P139-HD

DIGITAL AUDIO SYSTEM

BELL 204 / 212/ 412 INSTALLATION

MDL GA212 Rev A STC SR02270SE

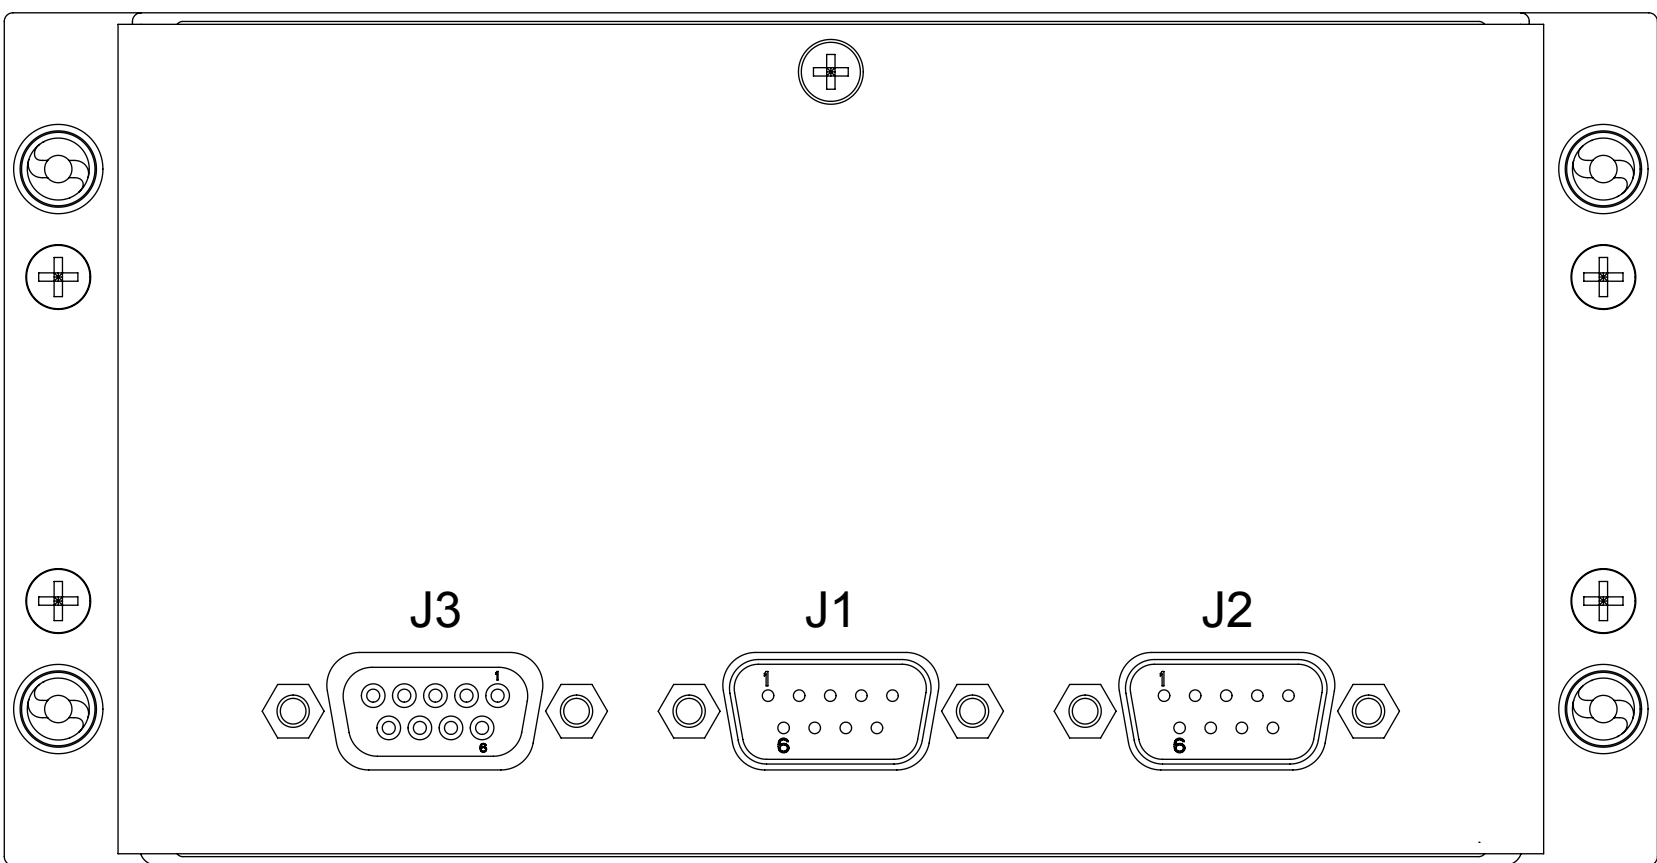
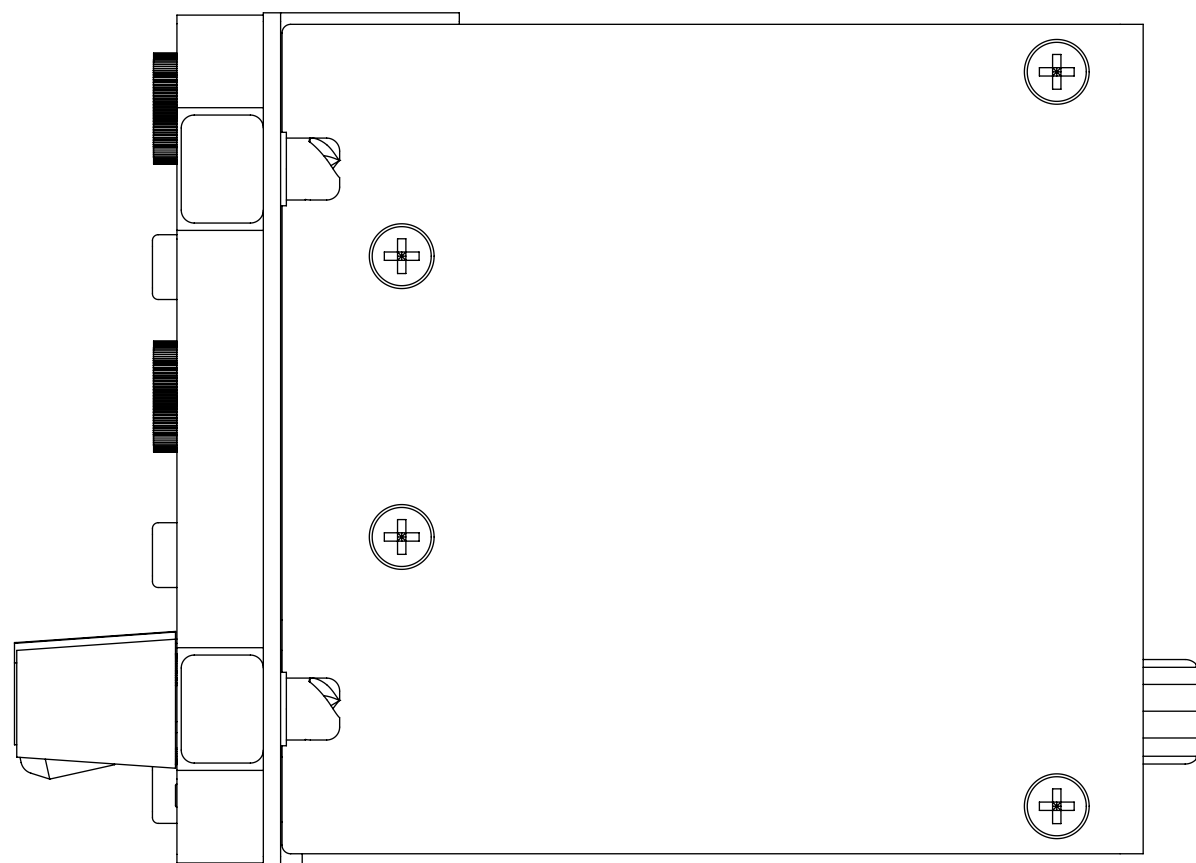
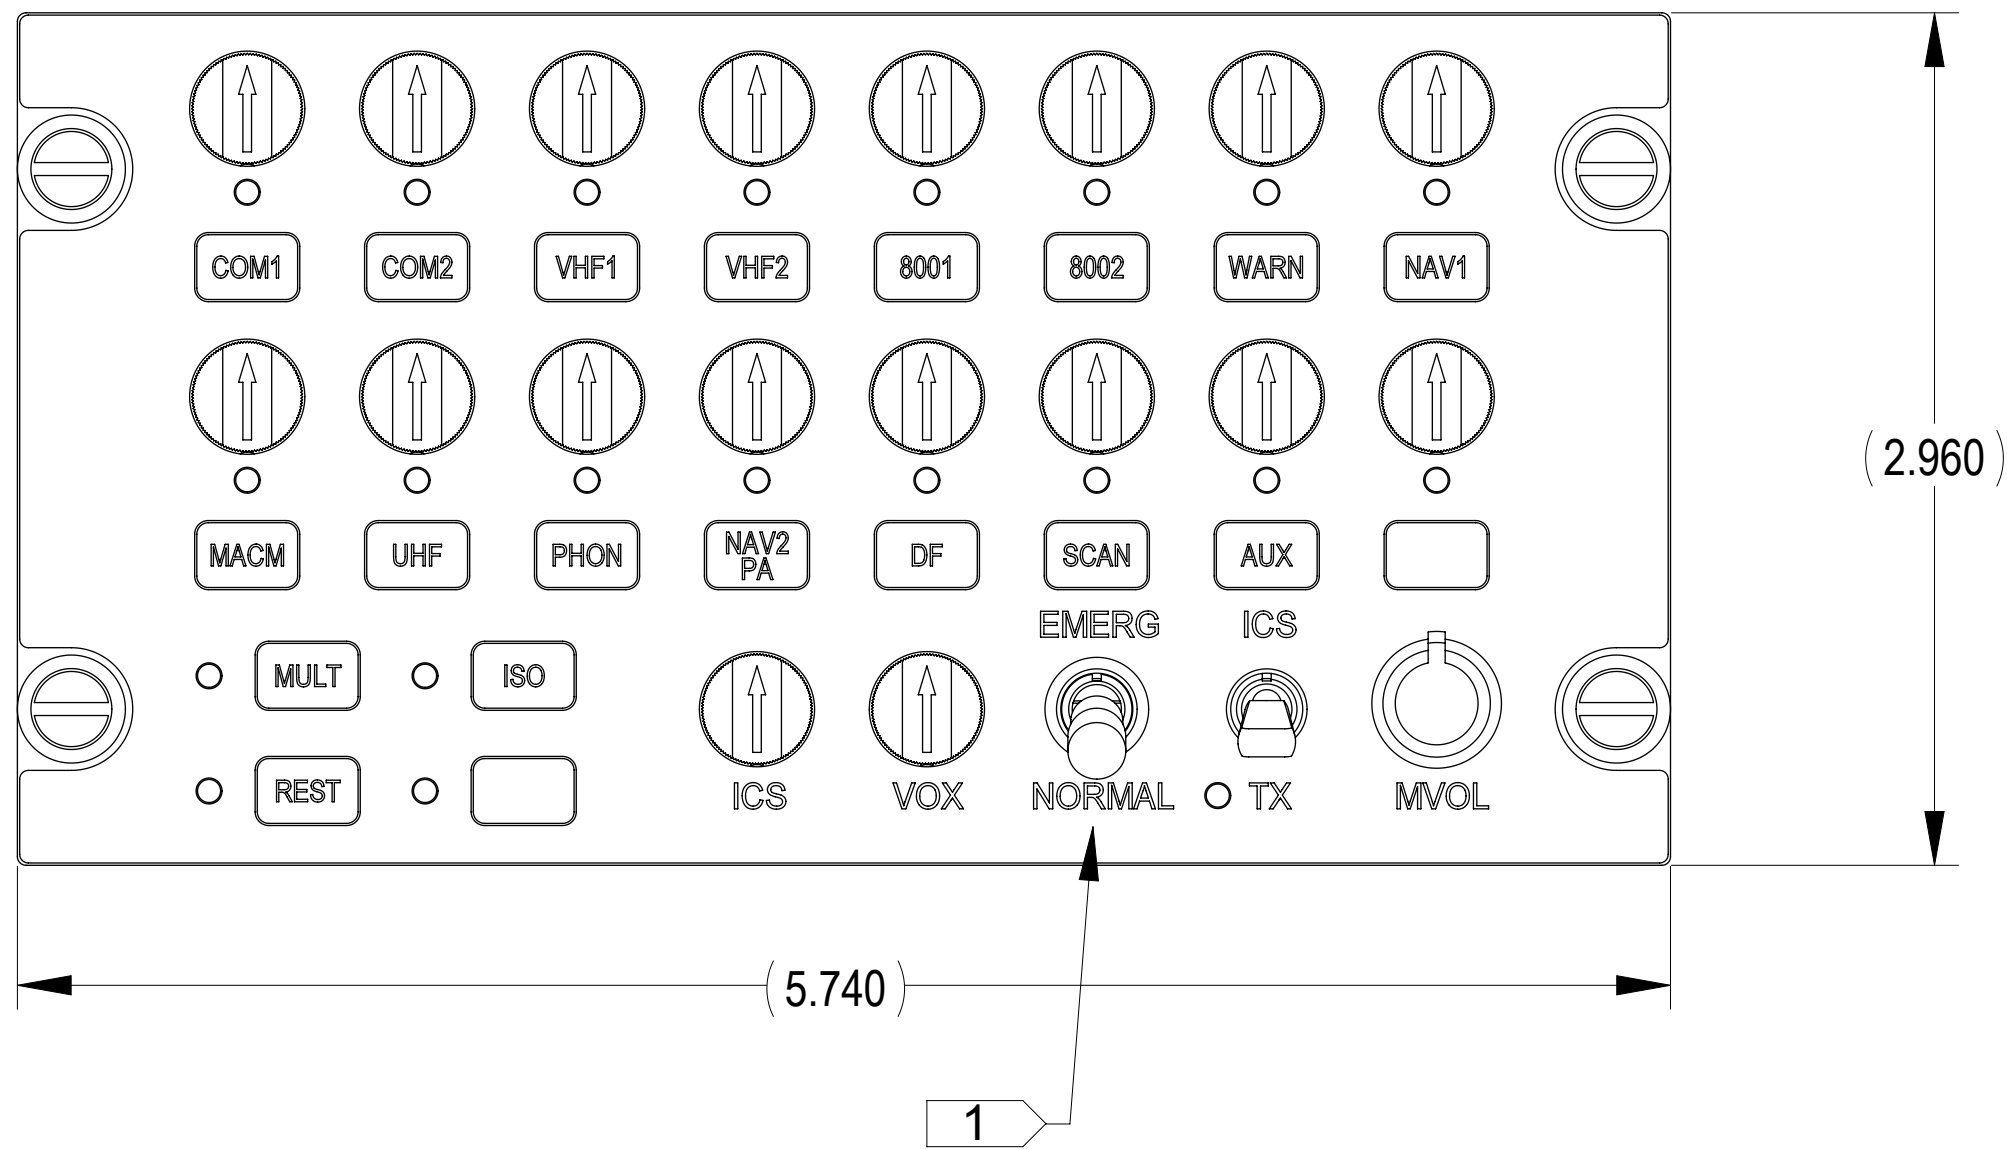
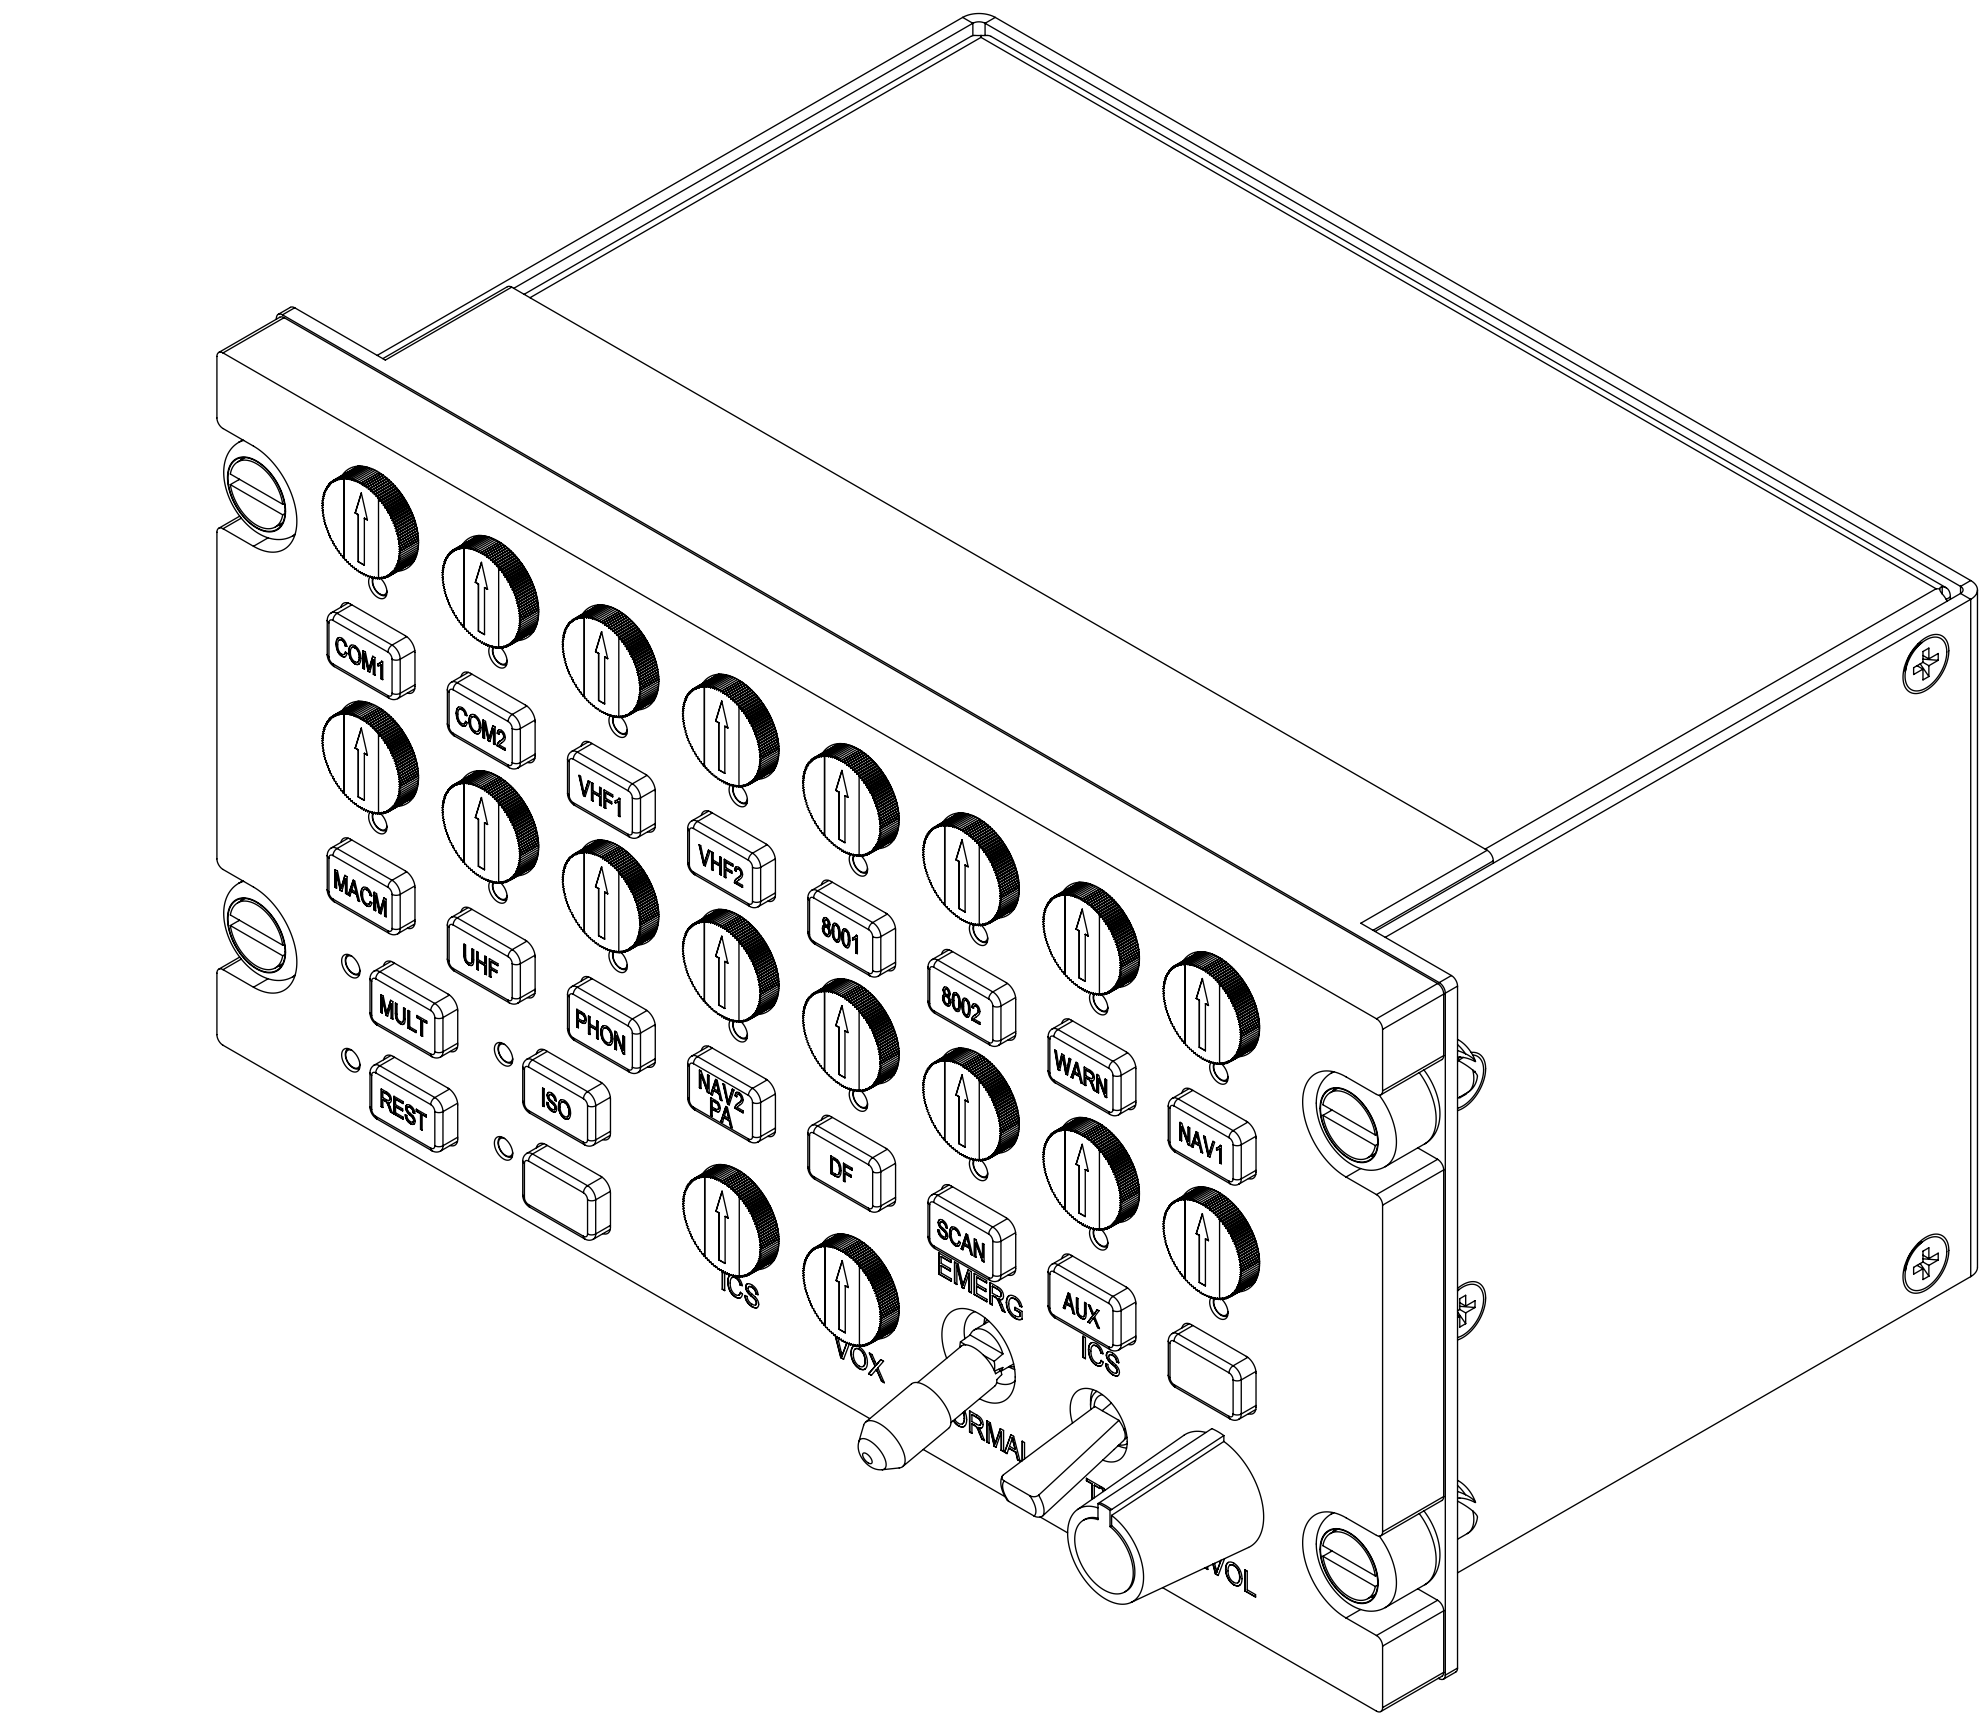
G13115: Revised labeling notes to engineering standards.

REVISIONS		
REV	DESCRIPTION	APPROVED/DATE
A	ADDED P/N G13115NS	10/15/12 CLB
B	REVISED NOTES	3/26/14 CLB
